Work Order ID 135104

Item Name: Fwd Crosstube - High 407

DART AEROSPACE LTD		Work Order:	<i>135104</i>
Description: Crosstube High Fwd (407)		Part Number:	D407-667-105
Inspection Dwg: D407-667-145	Rev: C	Page 1 of 1

DRAWING NO. D407-667-145	TITLE CROSSTUBE ASS'Y (407 HIGH FWD)	REV. C	DART AEROSPACE LTD ENGINEERING ORDER		D.E.O. NO. D407-667-145-C-1	SHEET NO. SHEET 1 OF 1	SCALE NTS
DRAWN 47	CHECKED 155	MFG. APPR. 155	APPROVED 155		DE APPR. 155		
DATE 11.07.15	DATE 11.07.22	DATE 11.07.22	DATE 11/07/22		DATE 11.07.21

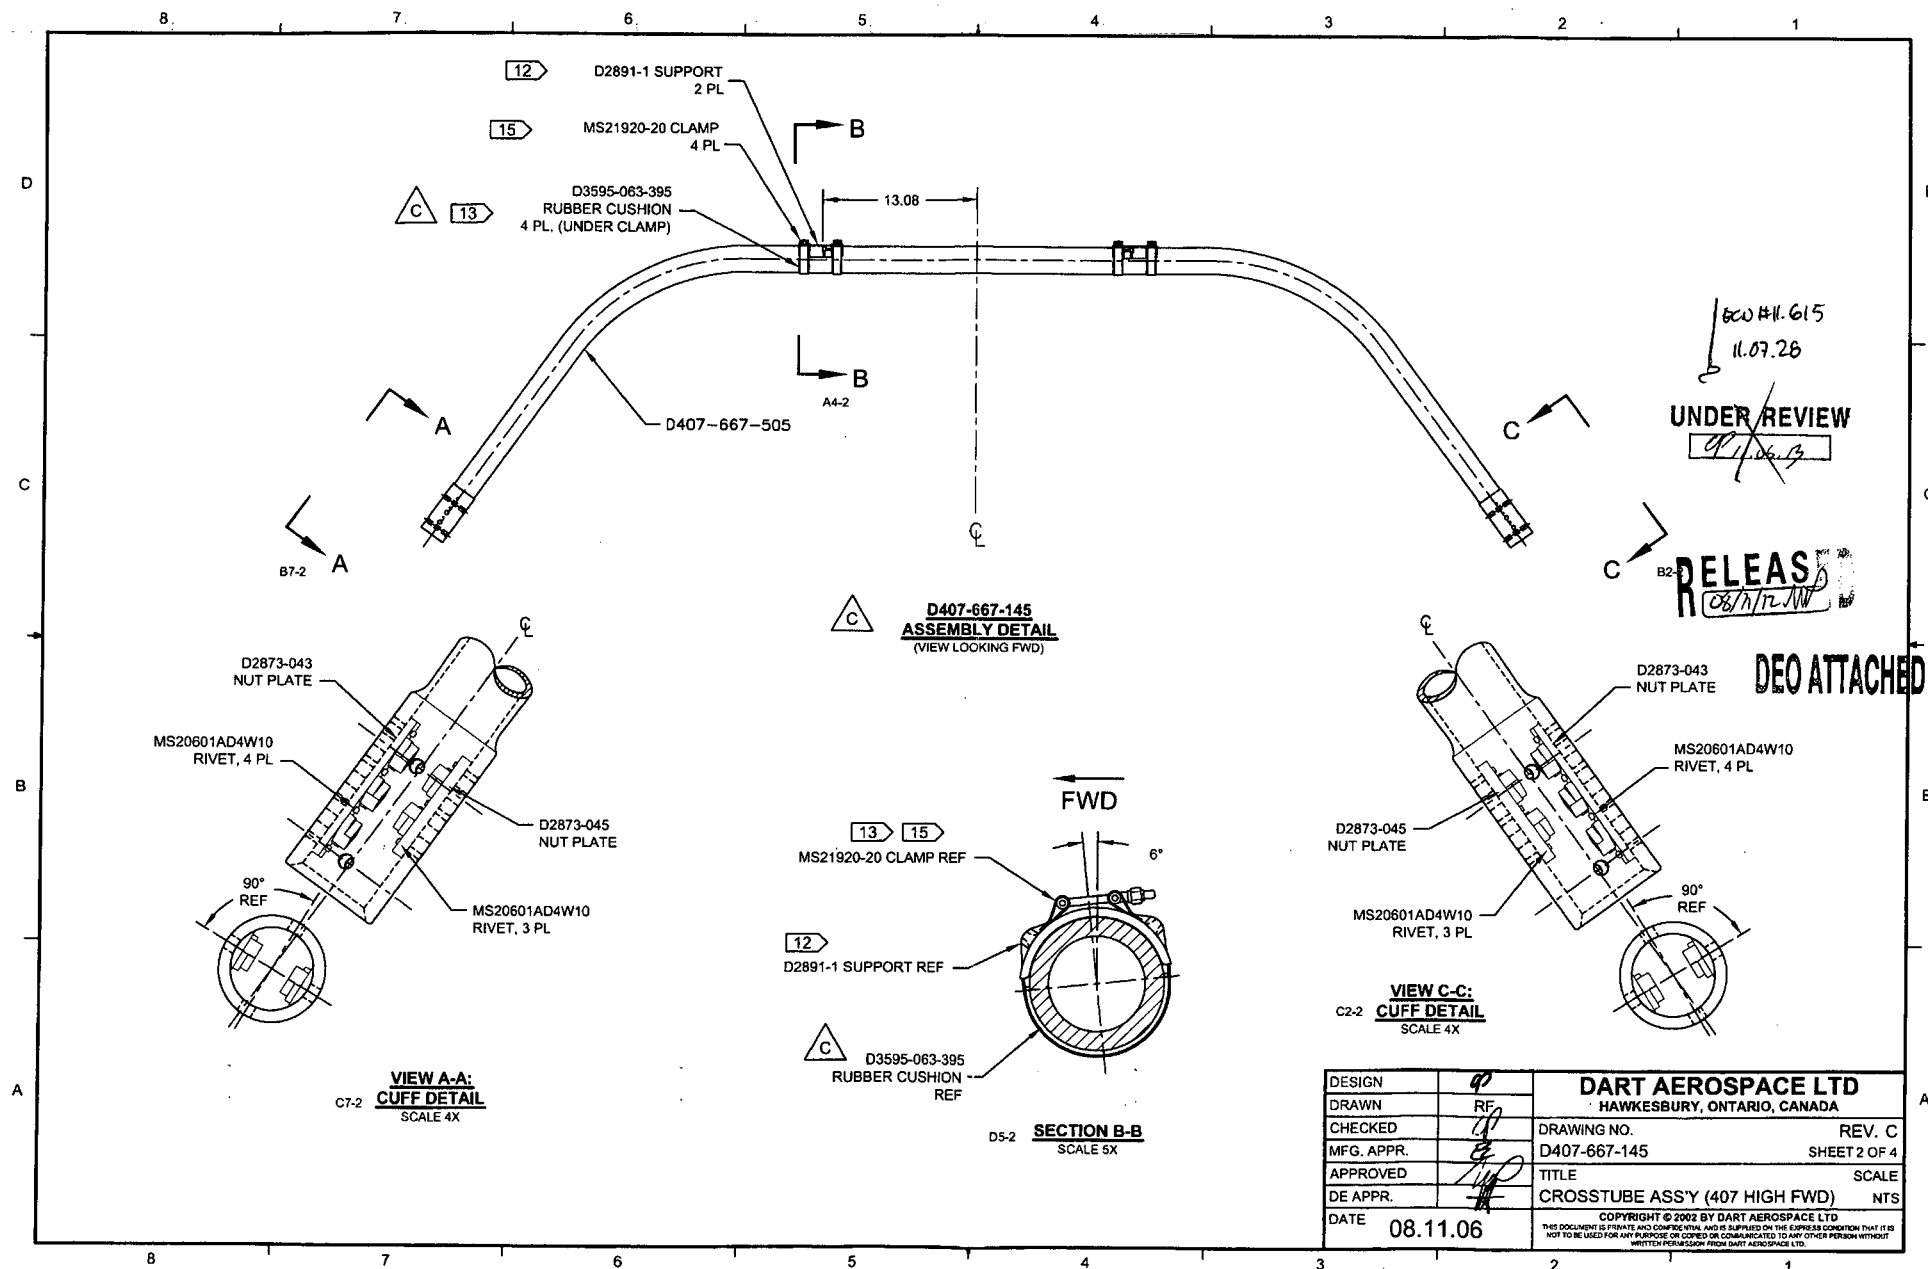
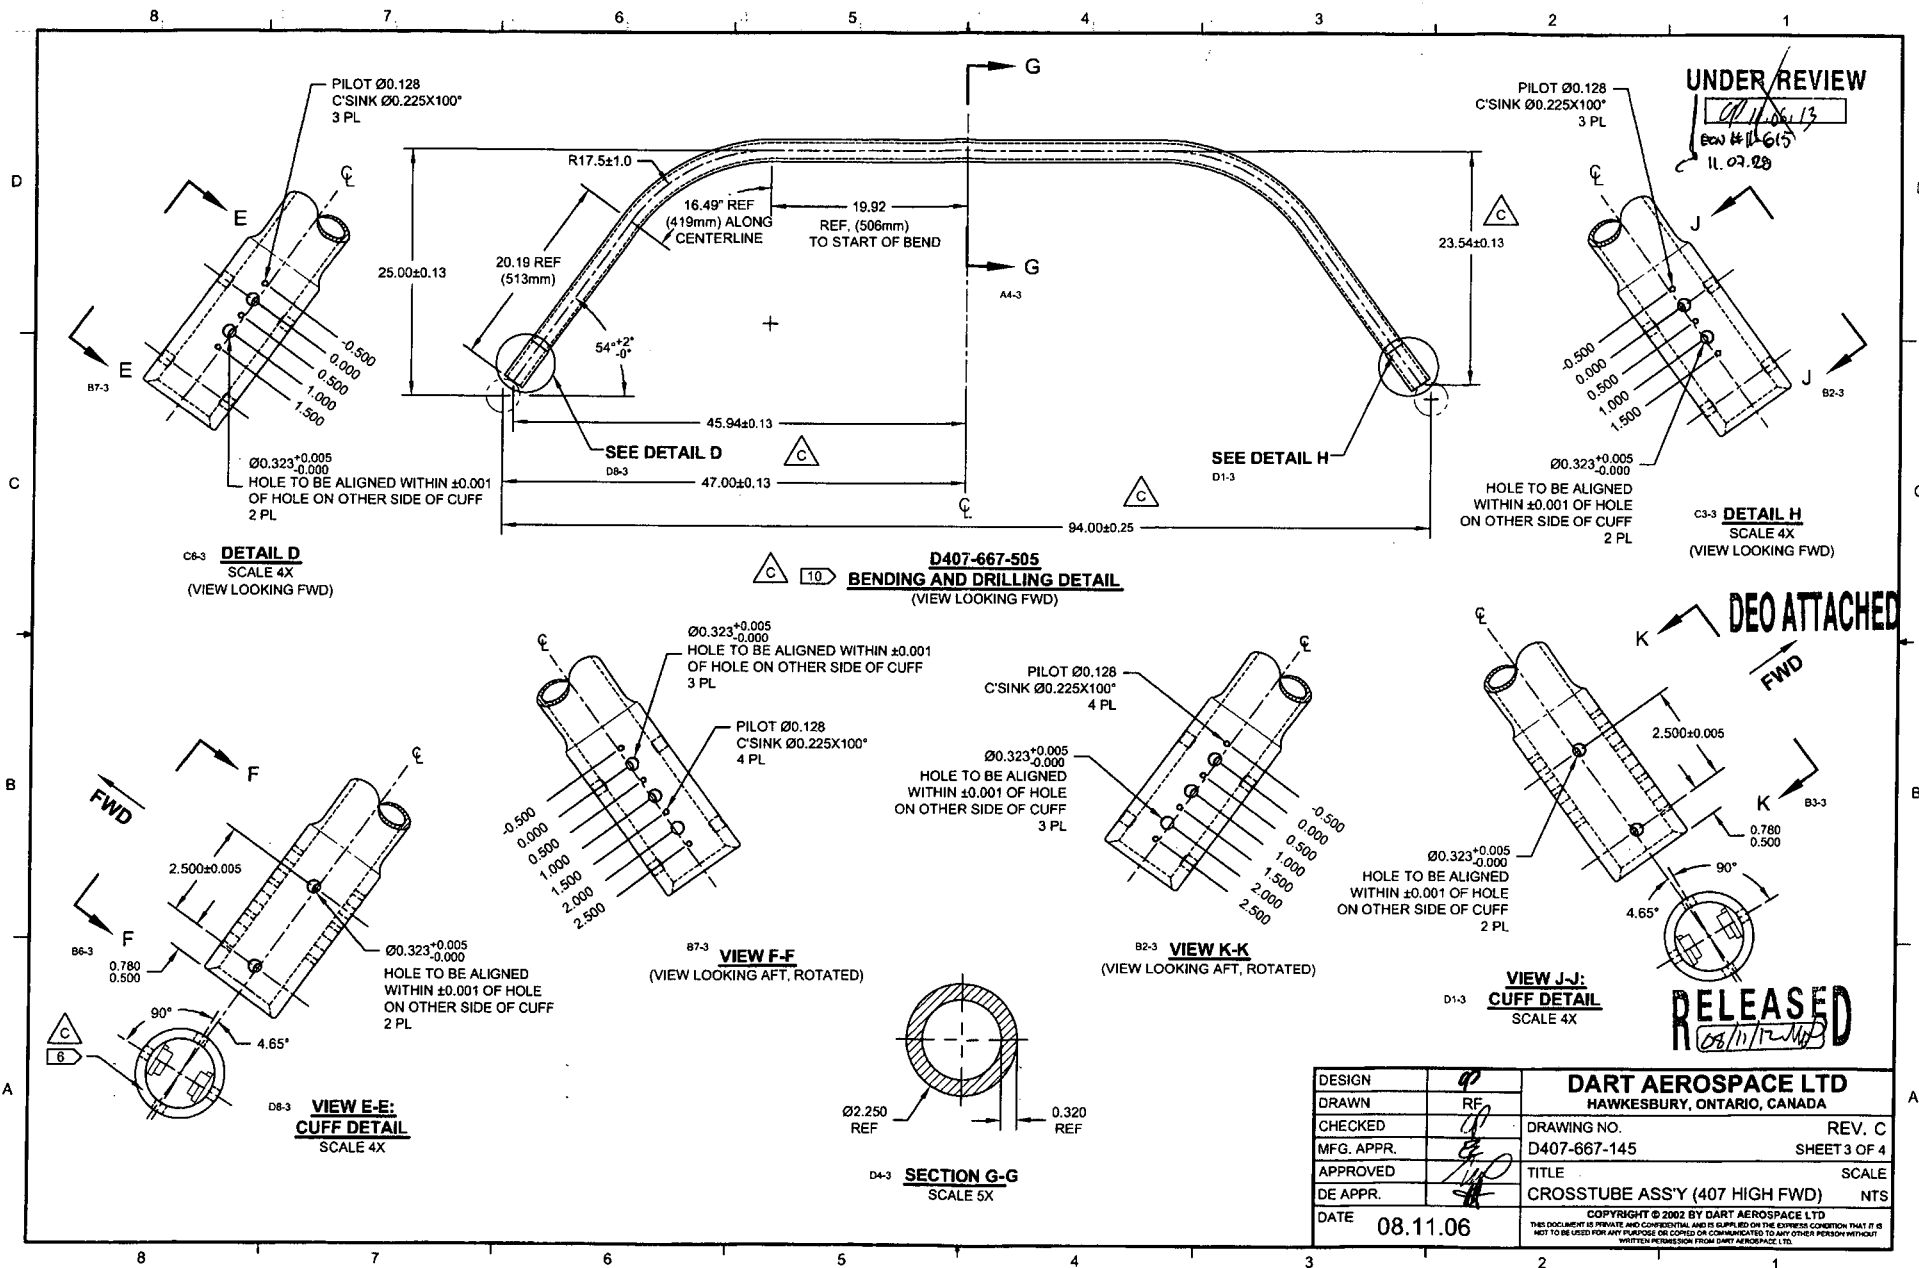
PURPOSE:

REPLACE MAGNOBOND WITH PROSEAL.

IS:

Item	Qty -145	Part Number	Description
9	A/R	PROSEAL 890 B-2	SEALANT, AMS-S-8802 CLASS B-2

WAS:

9	A/R	MAGNOBOND 6398	ROCKWELL SPECIFICATION RBO-120-023 ADHESIVE (TEXTRON/BELL SPEC. 299-947-100, TYPE II, CLASS 2 ADHESIVE)
---	-----	----------------	---

NOTE 12 & 15, SHEET 1 IS AMENDED AS FOLLOWS:

IS:

- 12) TO INSTALL D2891-1 SUPPORT: ABRASE MATING SURFACE OF SUPPORT AND CROSSTUBE WITH 180-GRIT SANDPAPER AND REMOVE RESIDUE WITH MEK (OR EQUIVALENT). APPLY A 0.04" TO 0.07" THICK LAYER OF PROSEAL 890 CLASS B-2 (OR AMS-S-8802 CLASS B-2) SEALANT TO MATING SURFACE OF SUPPORT.
- 15) TORQUE CLAMPS 80 TO 100 IN.-LB. ENSURE AT LEAST 1.5 THREADS SHOWING IN SAFETY AND THAT NUT HAS NOT BOTTOMED-OUT AFTER TORQUING. **PRIOR TO PACKAGING, RE-CHECK TORQUE ON CLAMPS AFTER PROSEAL 890 SEALANT HAS CURED FOR 72 HOURS.**

WAS:

- 12) INSTALL D2891-1 SUPPORT USING 0.03" TO 0.06" THICK LAYER OF MAGNOBOND 6398 PER QSI 015. LET CURE FOR 12 HOURS AFTER INSTALLATION AND PRIOR TO PACKAGING.
- 15) TORQUE CLAMPS 80 TO 100 IN.-LB. ENSURE AT LEAST 1.5 THREADS SHOWING IN SAFETY AND THAT NUT HAS NOT BOTTOMED-OUT AFTER TORQUING.

DRAWING NO. D407-667-145	TITLE CROSSTUBE ASS'Y (407 HIGH FWD)	REV. C	DART AEROSPACE LTD ENGINEERING ORDER		D.E.O. NO. D407-667-145-C-2	SHEET NO. SHEET 1 OF 1	SCALE NTS
DRAWN AJS	CHECKED	MFG. APPR.	APPROVED		DE APPR.		
DATE 12.08.02	DATE 12.08.02	DATE 12.08.02	DATE 12.08.02		DATE 12.08.02

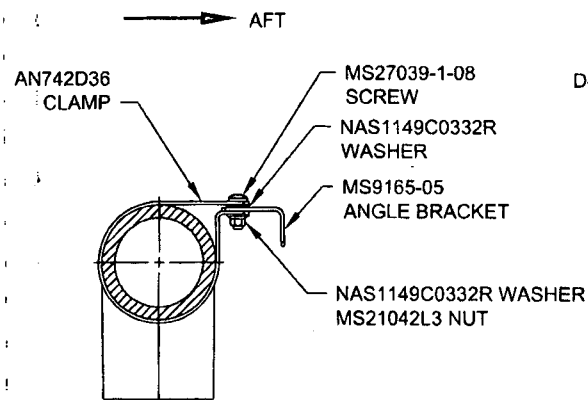
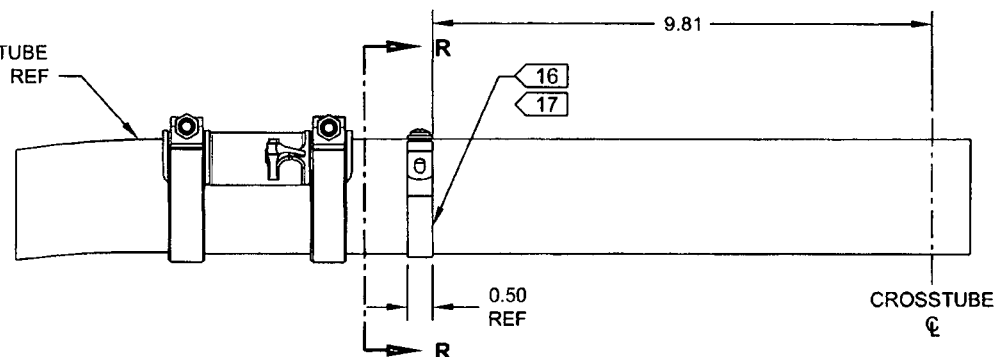
PURPOSE:

ADD ELECTRICAL GROUNDING STRAP

CHANGE:

ITEM	QTY	PART NUMBER	DESCRIPTION
1	X	D407-667-145	CROSSTUBE ASSEMBLY (407 HIGH FWD)
10	2	AN742D36	CLAMP
11	2	MS9165-05	ANGLE BRACKET
12	2	MS21042L3	NUT (OR MS21042-3)
13	2	MS27039-1-08	SCREW
14	4	NAS1149C0332R	WASHER (OR AN960C10L)

GENERAL NOTES:

- 16) MASK AREA UNDER CLAMP PRIOR TO PAINTING
- 17) SEAL EDGES WHERE AN742D36 CLAMP MEETS WITH THE CROSSTUBE USING SIKAFLEX-241/-291 OR MIL-S-8802 CLASS B2 OR PROSEAL 890 SEALANT
- 18) PERFORM RESISTANCE CHECK TO ENSURE MAX RESISTANCE IS 10 MILLIOHMS
